Economic Commission for Europe**Inland Transport Committee****World Forum for Harmonization of Vehicle Regulations****Working Party on Noise****Sixtieth session**

Geneva, 1-3 September 2014

Regulation No. 117 (Tyre rolling noise and wet grip adhesion)**Proposal for Supplement 6 to the 02 series of amendments to
Regulation No. 117****Submitted by the expert from the Russian Federation¹**

Figure 1

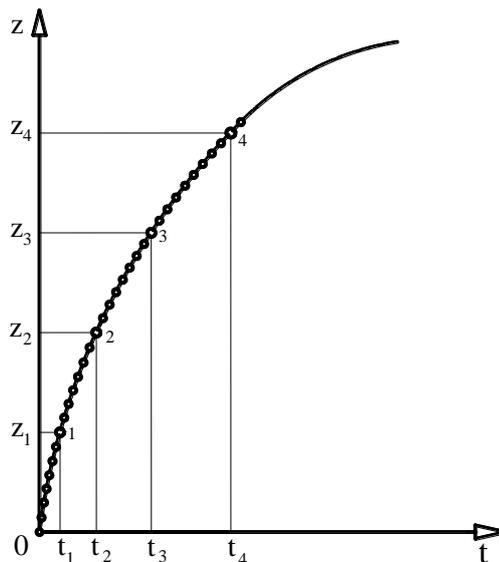
1. Record dependency "distance-time" of rotating body decelerated from peripheral with a speed range such as 82 to 78 km/h or 62 to 58 km/h dependent on a PC or CV tyre in a discrete form (figure 1) for a rotating body:

2. Approximate recorded dependency by continuous, monotonic, differentiable function:
 - 2.1. Choose the value nearest to the maximum of z dividable by 4 and divide it into 4 equal parts with bounds: 0, $z_1(t_1)$, $z_2(t_2)$, $z_3(t_3)$, $z_4(t_4)$.
 - 2.2. Work out the system for 4 equations each of the form:

4.2. Finding the value nearest to the maximum z equals n , dividable by 4, dividing it into 4 equal parts and recording the coordinates of 4 points on the experimental curve (see figure 1).

4.3. Working out the equation system on the basis of the formula in paragraph 2.3 of Annex 6, Appendix 5 with a substitution of 4 point coordinates as shown in figure 1:
